MECKLENBURG COUNTY HEALTH DEPARTMENT

APPLICATION FOR PERCOLATION TEST

SITE INVESTIGATION REPORT
INDIVIDUAL SEPTIC TANK SYSTEM
MISS SUBSURFACE,
SOIL ABSORPTION,
EFFLUENT DISCHARGE

SIP NO. 12828
T.C. NO. P.O.135-351-01
C/E DATE _____

[illegible] Diagram on Back (Include: Soil areas, property lines, roads, streams, gullies, wet areas, fill areas, wells, water bodies, slope patterns, etc.)

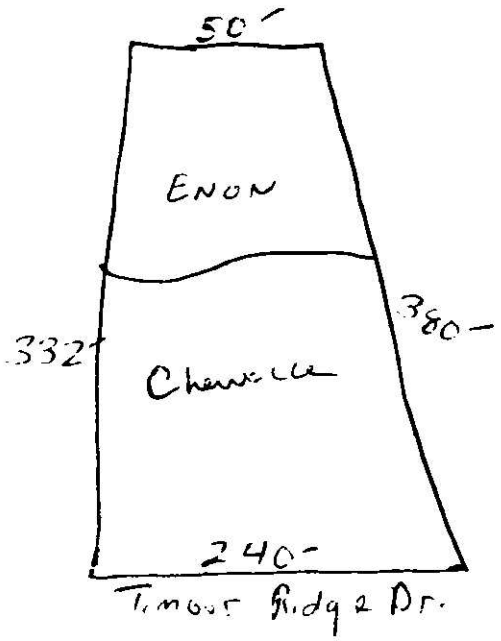
[illegible] Recommendations/Comments: Based on this investigation the lot was found to have soils generally unsuitable for installation of septic tank systems.
